RE: Occidental Chemical Corporation, Montague, Michigan - MID 006 014 906
Revised Technical Impracticability Evaluation

Post-Implementation Technical Impracticability Evaluation for Groundwater
Restoration at the Occidental Chemical Corporation Site in Montague, Michigan

Revision 01
September 2009

General Comments, TI Evaluation

Figure 3

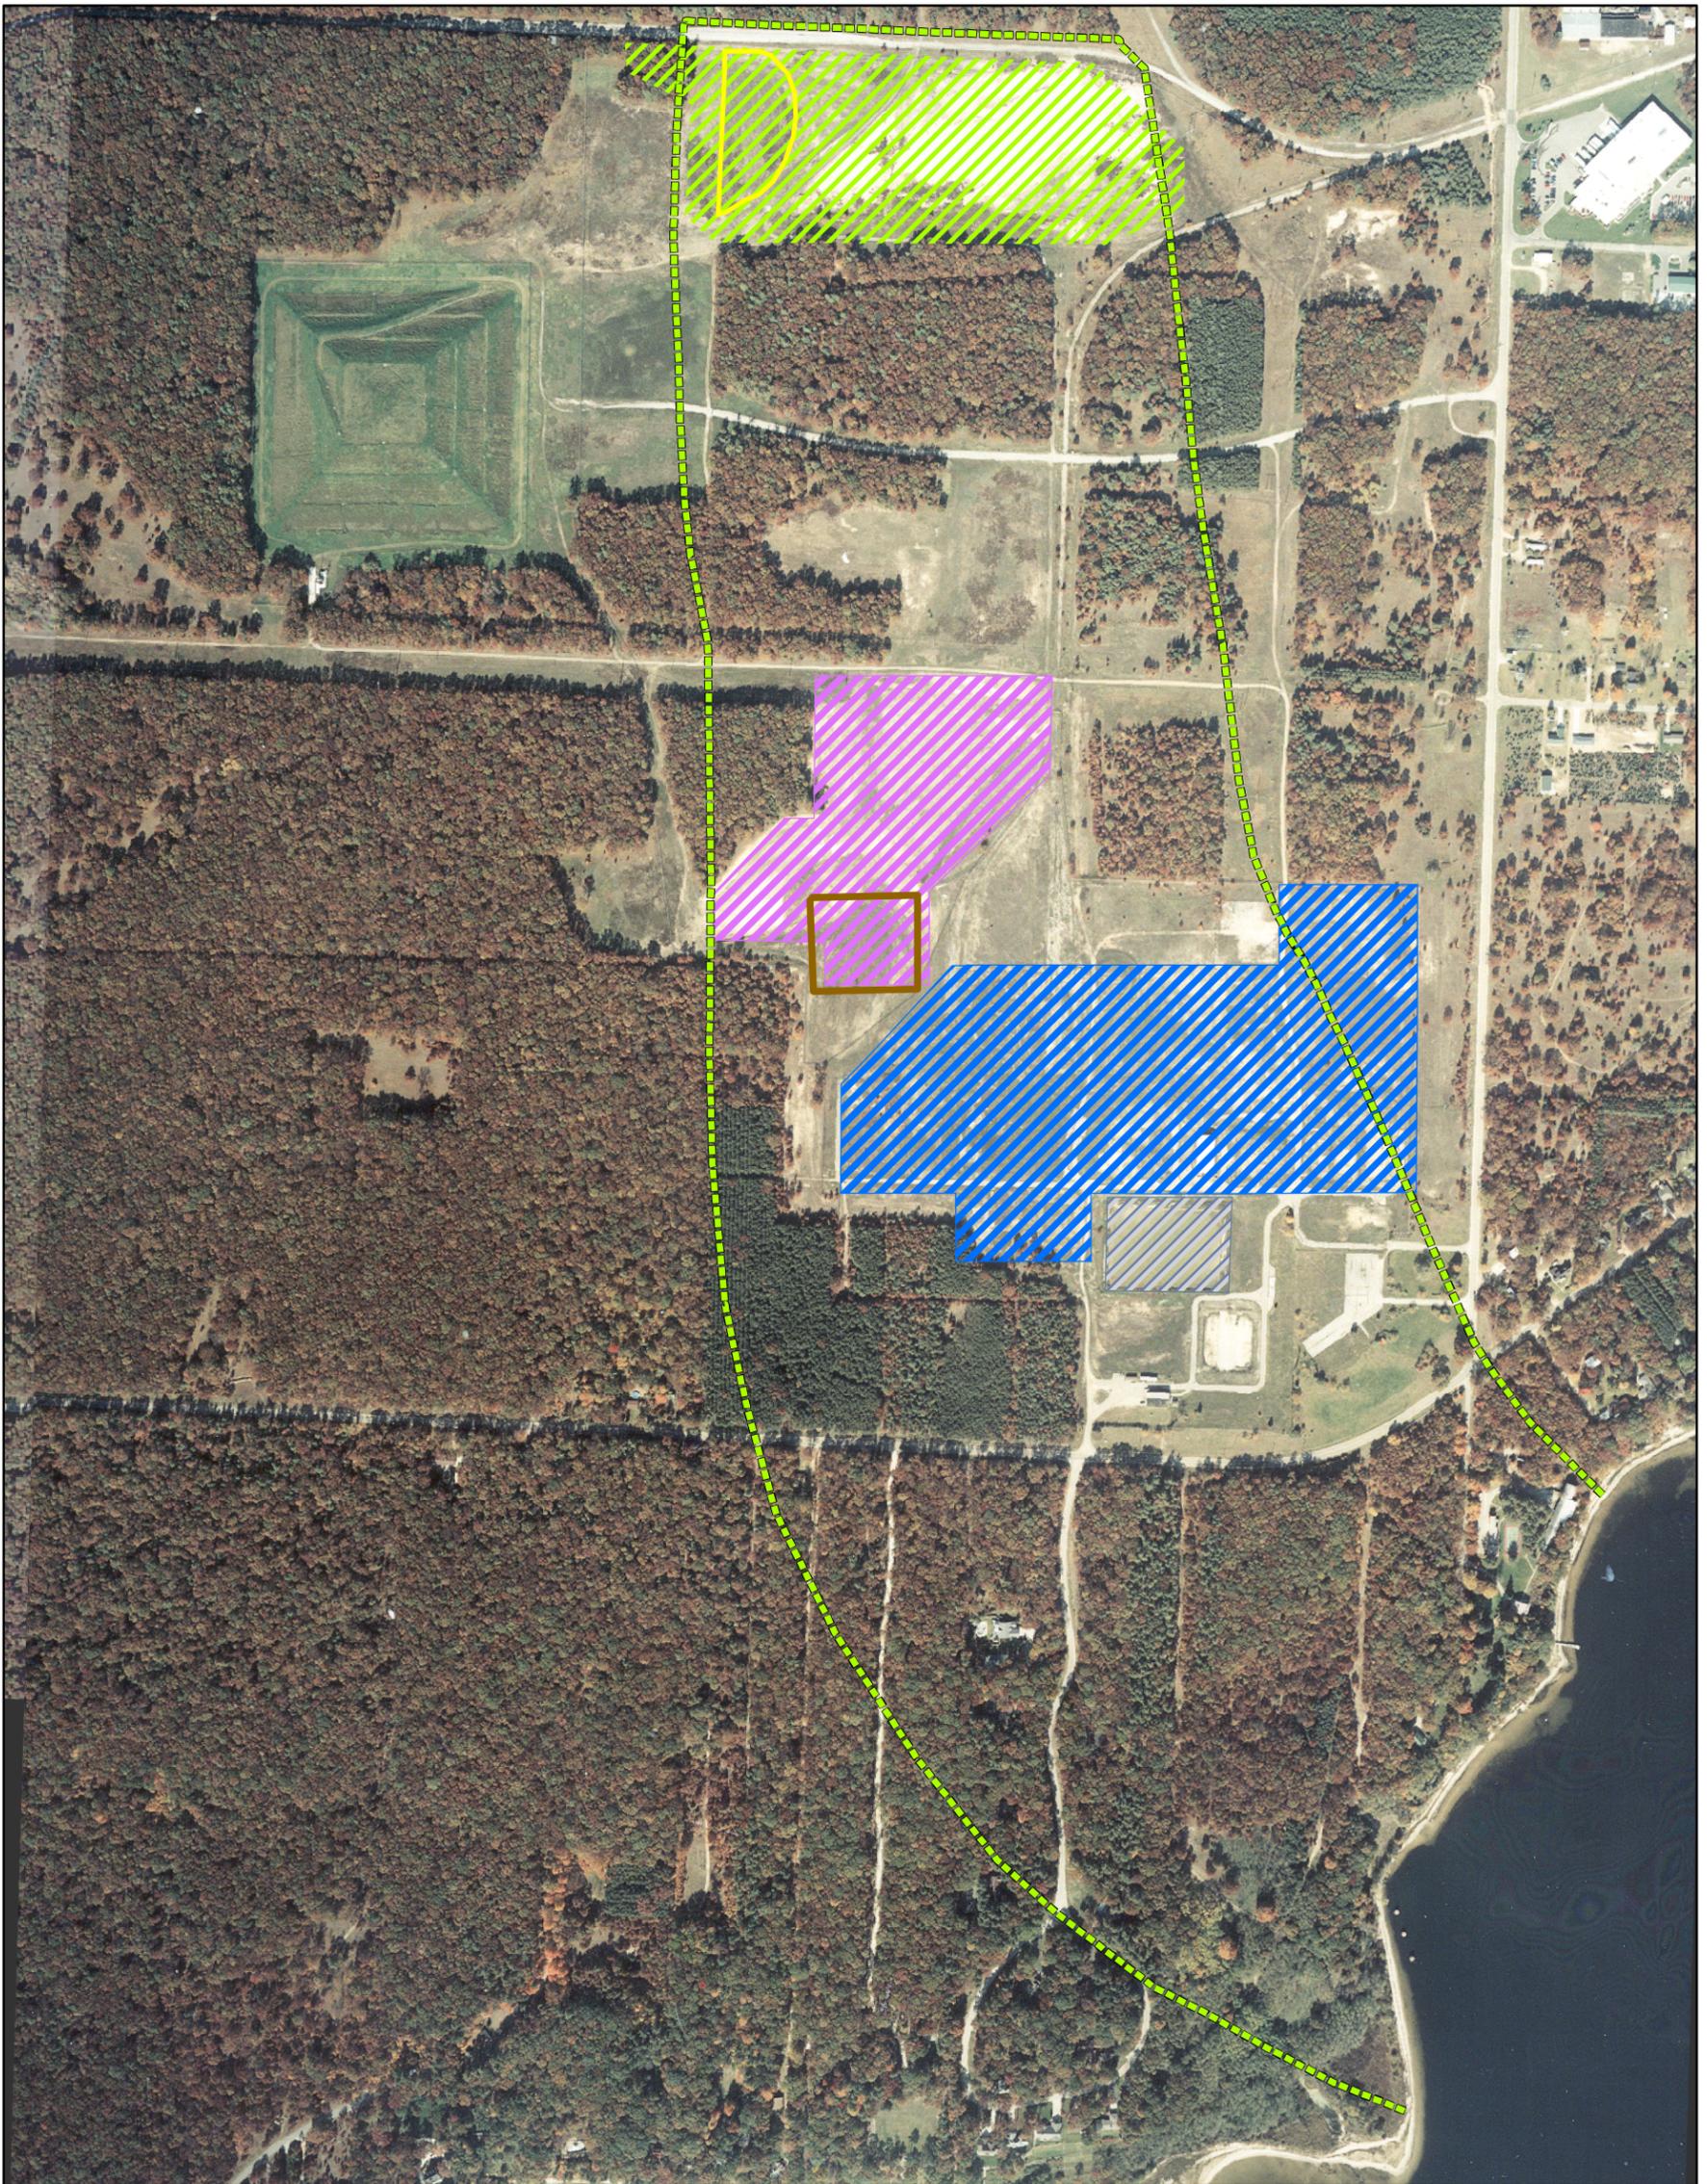
- 2) Section 1.3, page 4: The text identifies one of the residual source areas within the Northern Exposure Area as the Former Primary Disposal Area. In Figure 3, and elsewhere, this area is also called the Former Drum Disposal Area and the Former Primary Disposal Pile (see Figure 6). The Former Primary Ash Disposal Area is also called the Former Fly Ash Area in the report. Ensure that the text, figures, tables, and appendices in the TI Evaluation consistently identify the names of the four residual source areas.

The text and figures have been revised to consistently label and reference the four residual source areas as follows:

Figure 5		
Historical Remedial Actions To Date		
Former Occidental Chemical Site Montague, Michigan		
98355	April 2009	Creator: CPP090109
		Q.C.: JT

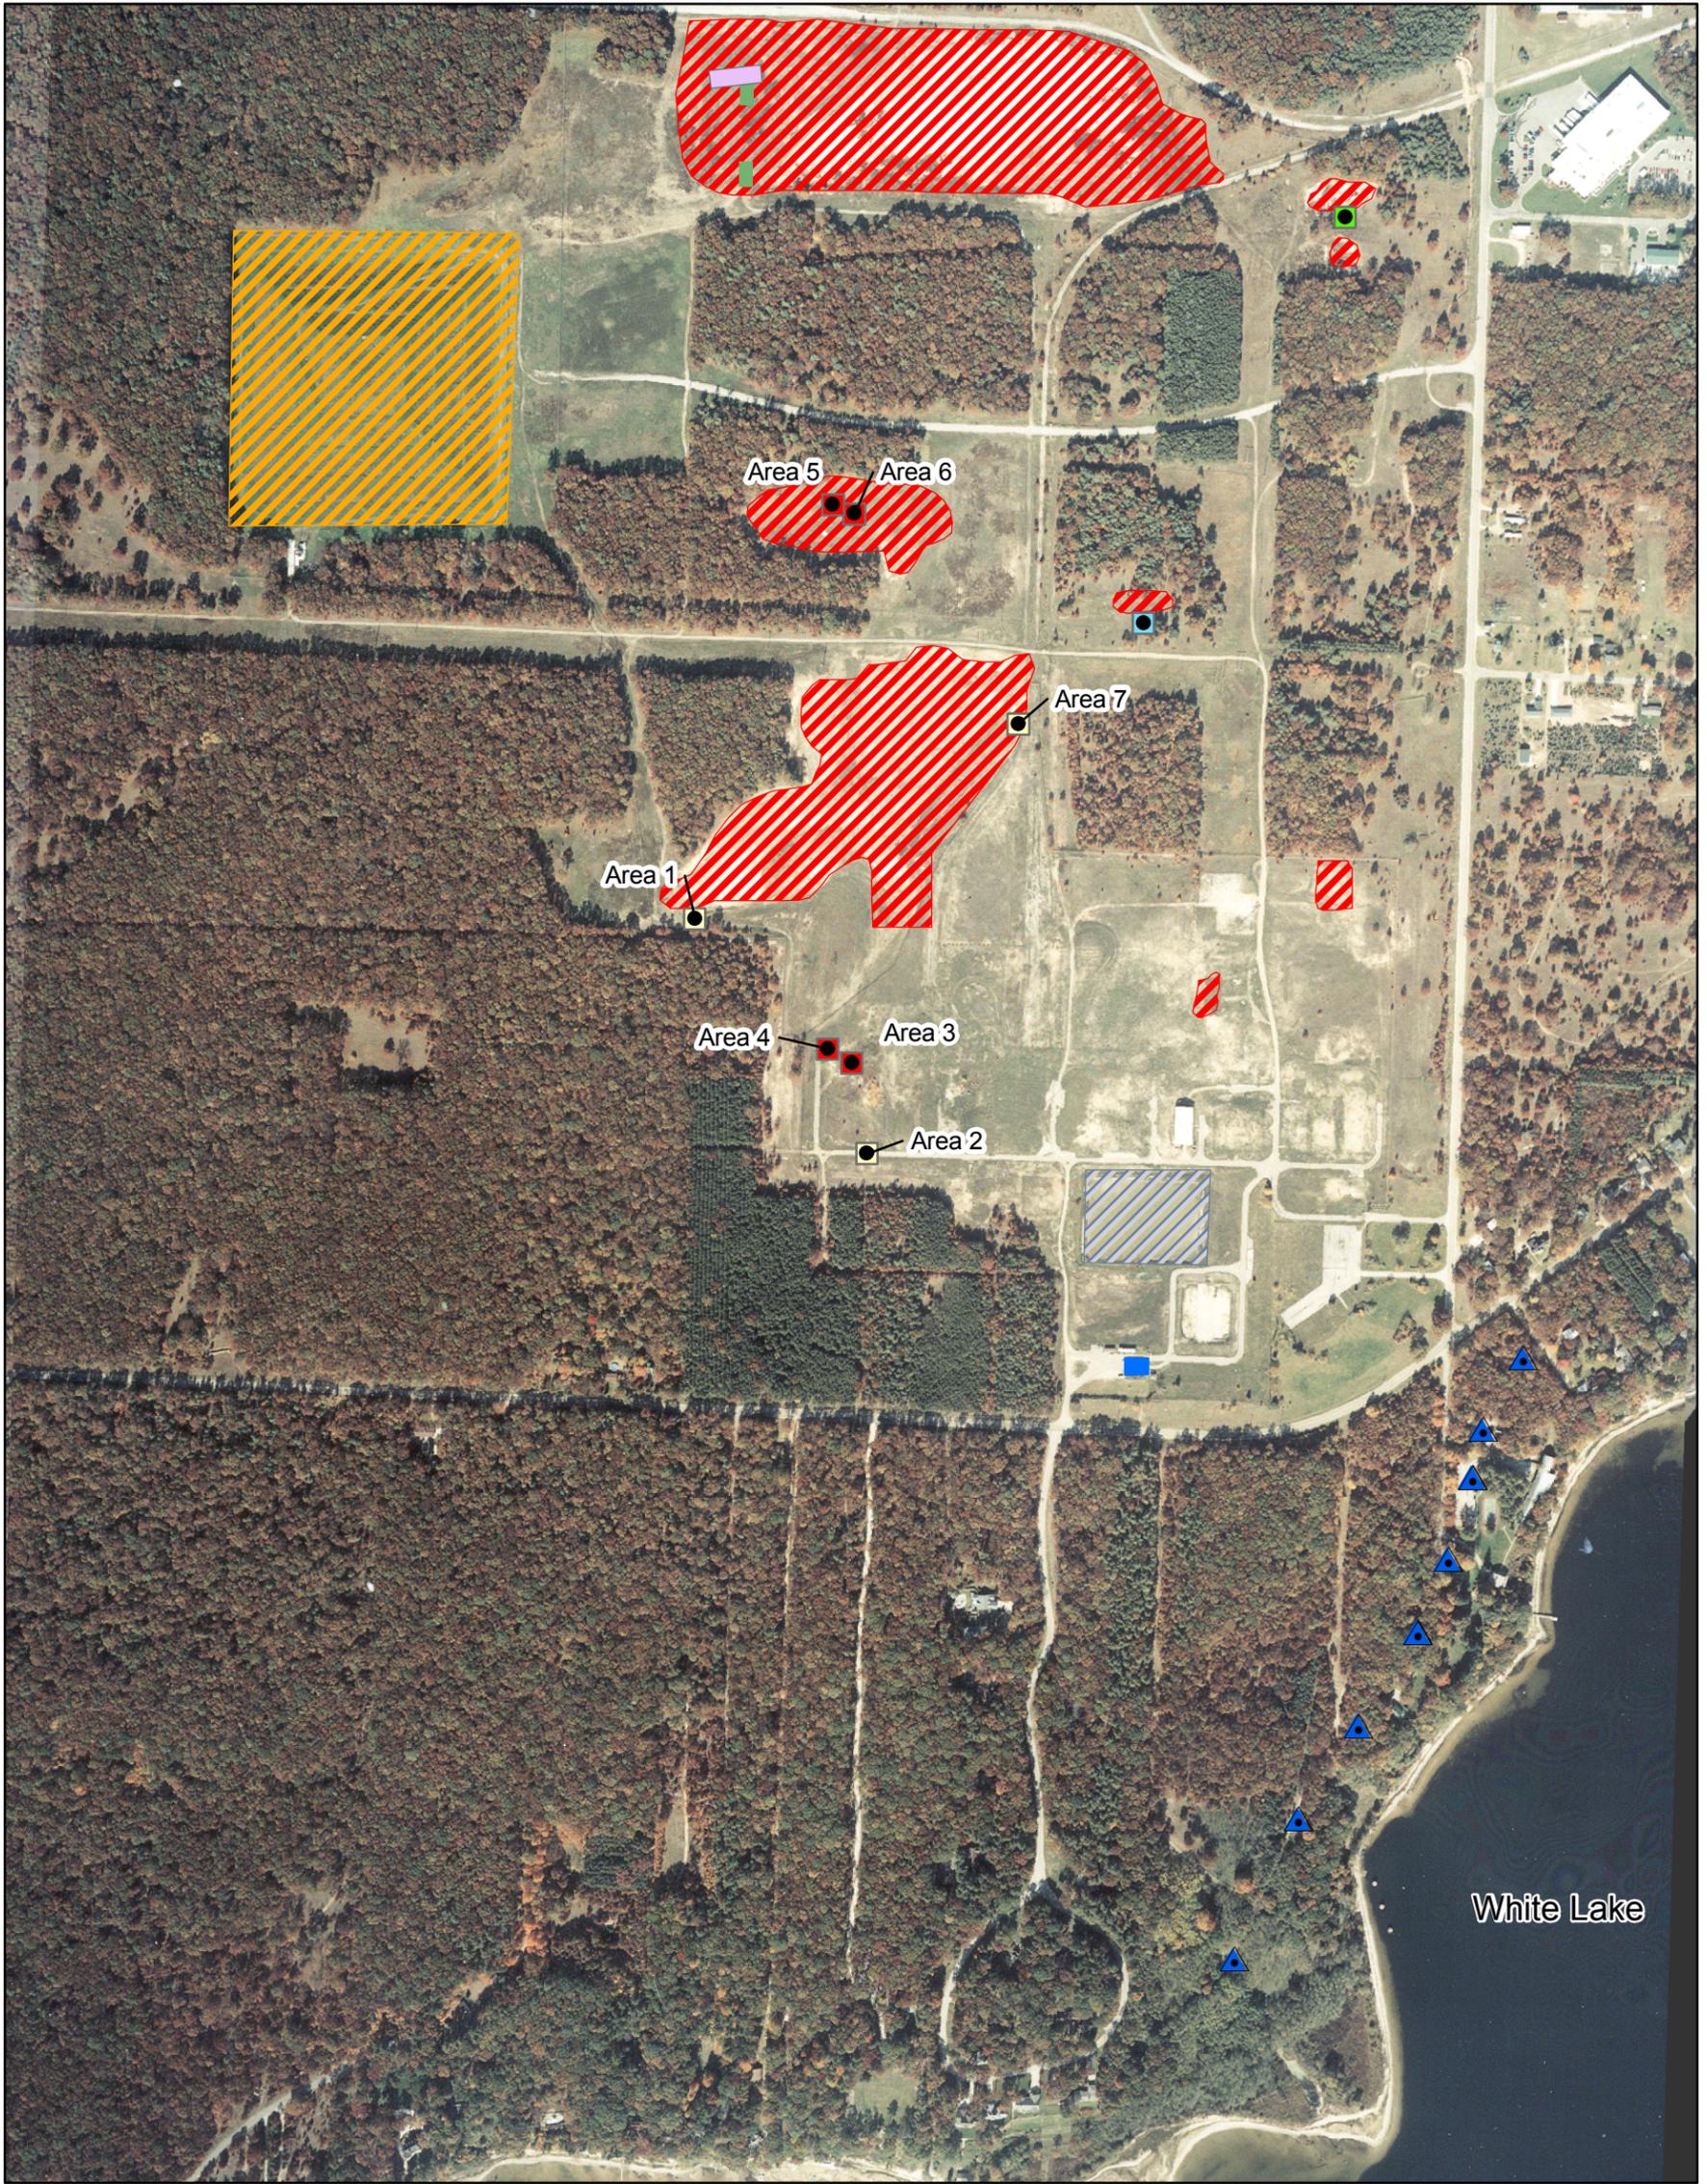
- 5) Section 1.5.4, page 8: The text only discusses capping of the seven small areas in the former industrial portion of the Site. In addition to capping, excavation and off-site disposal was performed. Include a discussion of the volume of excavation performed at each of the seven areas, including the acreage or square footage of each area, and the extent of the area requiring capping. Figure 5 depicts the seven small areas and Former Burn Pit. The figure is not clear in differentiating between the localized areas and the prior excavated larger areas. For example, excavated and capped symbols, and localized soil capped areas symbols are used at nine locations. Consider identifying the unit names or dates of remediation for each of the areas in Figure 5.

Figure 5 has been revised to more clearly illustrate excavation and capping activities performed at the site. In addition, the text in the Revised TI has been modified to better reflect historical removal and capping activities summarized in Section 1.5.4.

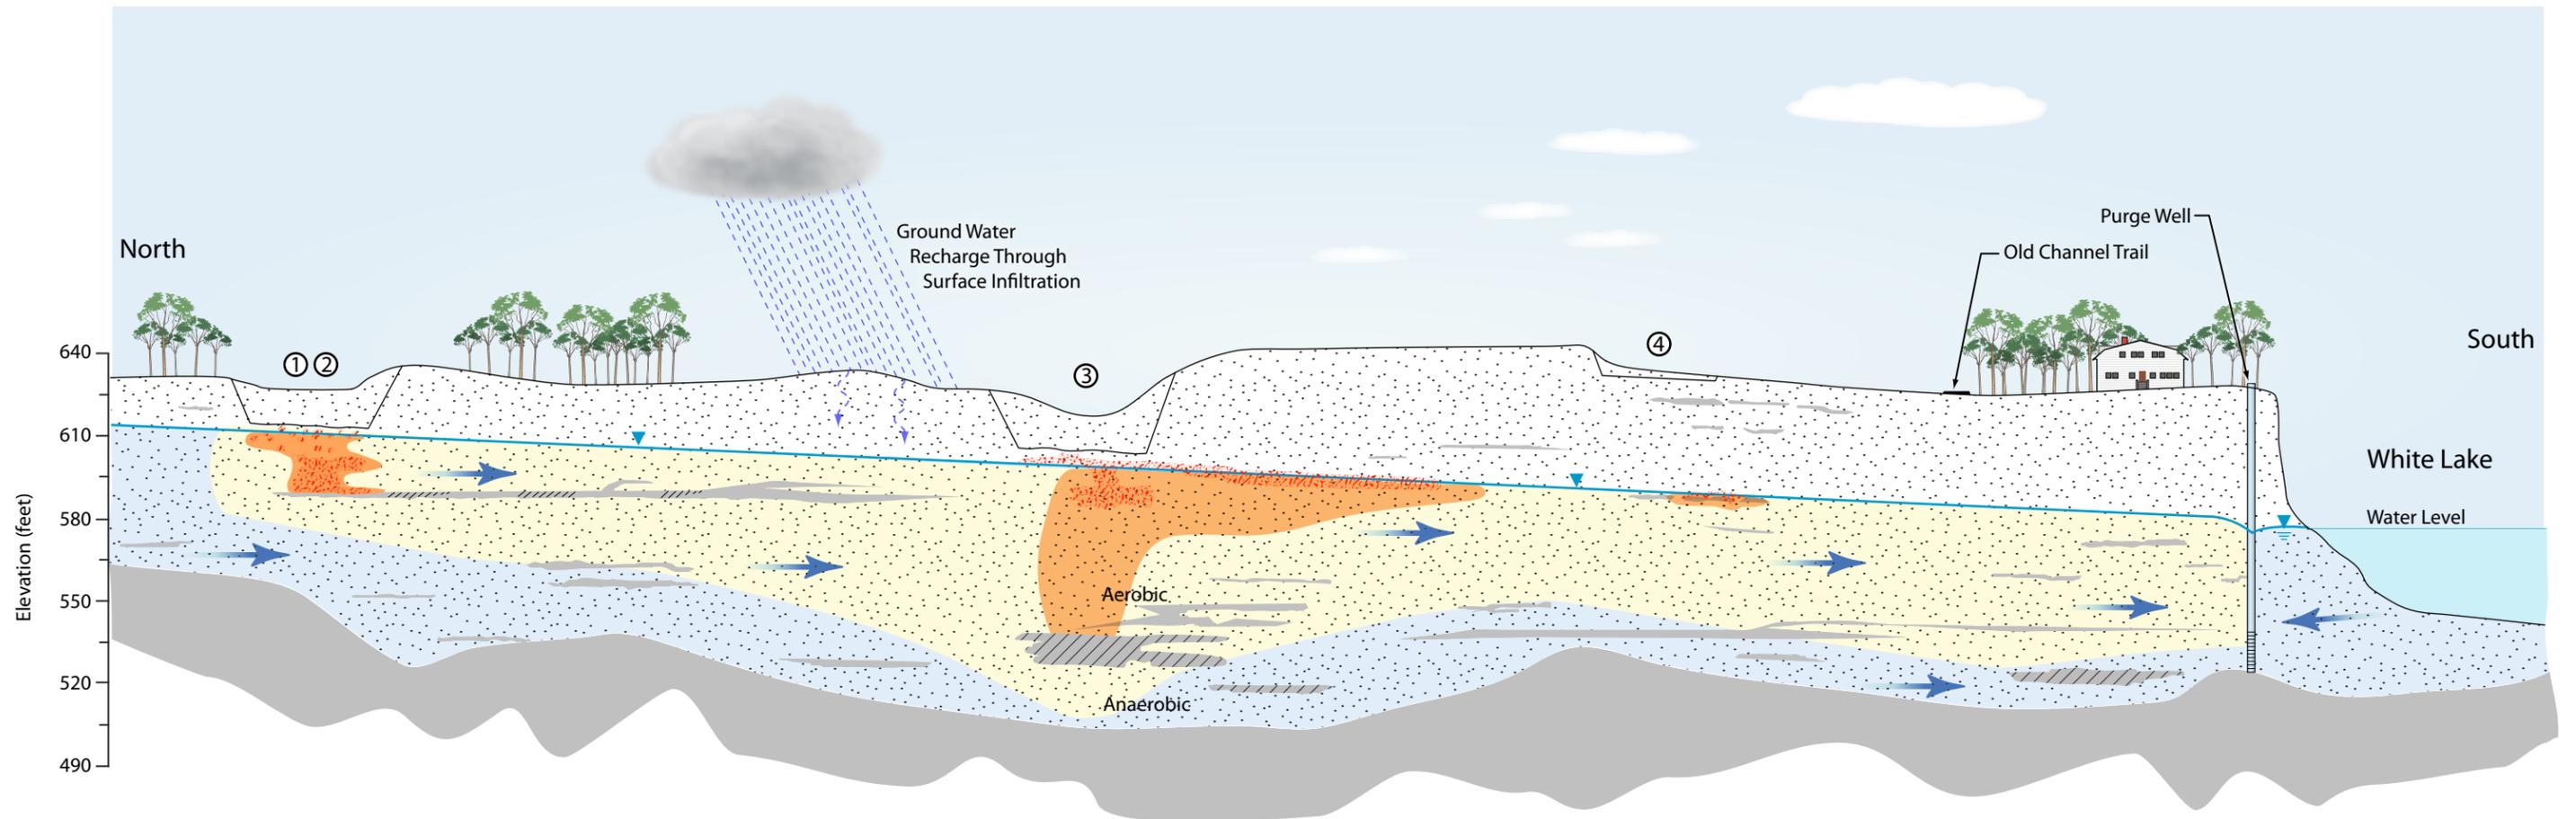
- 9) Section 3.1, page 11: The Site Conceptual Model (SCM) is graphically presented in Figure 6. A dissolved C-56 plume is shown to be present only beneath the Former Fine Chemical Production Area. Confirm that no dissolved C-56 plume exists at the other historical DNAPL entry locations (e.g., bullet 8 on page 12 states that a C-56 plume is located immediately downgradient from the source areas). The key in Figure 6 includes a yellow symbol for the dissolved VOC plume but this extensive plume is not shown in the SCM. Show the extent of the dissolved VOC plume in the foreground of the sand aquifer, and background of the DNAPL and dissolved C-56 plume. Include a symbol in the key representing the excavations at each of the historical DNAPL entry locations.

- 10) Section 3.3, page 13: Site elevations in the northern and central portions are stated to vary in elevation between 630 and 640 feet AMSL. Figure 6 shows these portions of the site to vary in elevation between 680 and 690 feet AMSL. Ensure that the site elevations are consistent between the text and the figures.

- 11) Section 3.4, page 16: In the text, groundwater is stated to be present at approximately 610 feet AMSL at the northern area. Figure 6 shows the water table in the northern area at 650 feet AMSL. Ensure that the groundwater elevations described in the text and figures are consistent. In Figure 10, show the groundwater contour lines in feet, not meters, for consistency of units throughout the report.

The Site Conceptual Model (SCM) is a generalized strike and cross-sectional view along the long-axis of the site. In the Revised TI Evaluation, the SCM **Figure 7** has been updated to include the Total VOC plume. The figure also provides more detailed visualization of C-56. The figure has been modified to also address EPA Comment 16 (below). Although the SCM serves as a generalized representation of Site conditions, and is based on lithostratigraphic and hydrogeological observations, it does not serve as a precise cross-sectional view of the Site.

Figure 7 has been adjusted to present current but approximated ground elevations in feet above mean sea level.
